# RCA-78-25-002-1: Retrofit Lower 12V Battery Bracket Reinforcement

<b>Document Type</b>	Customer Satisfaction Campaign Bulletin
<b>Date</b>	December 17, 2025
<b>Affected Region(s)</b>	USA, Europe
<b>Affected Model(s)</b>	EDV, RCV
<b>Model Year(s)</b>	2024
<b>Approximate Build Dates</b>	December 2023-November 2024
 Refer to <b>Open Containments</b> in ServiceOS to determine if this document applies to a specific vehicle.	
<b>Vehicle System</b>	78 - Low Voltage Electrical
<b>Minimum Service Location</b>	Mobile

## Required Parts

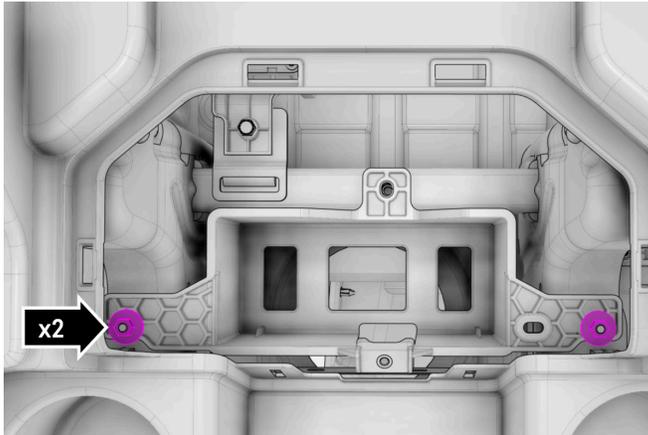
Part Number	Quantity	Engineering Name	Service Name/Notes
PT01470096-C	1	EDV-ALL: 12V BATTERY BACKSTRAP- SEAT PEDESTAL	Reinforcement, Lower 12V Battery Bracket

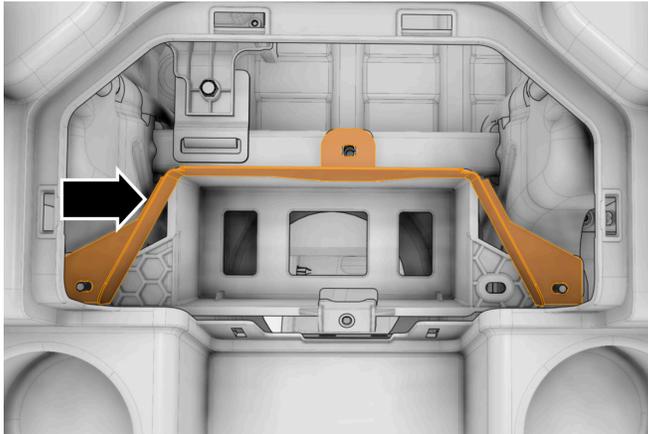
2.

3. Install:

4. Install:

Step Number	Torque (Nm)
4	9.5
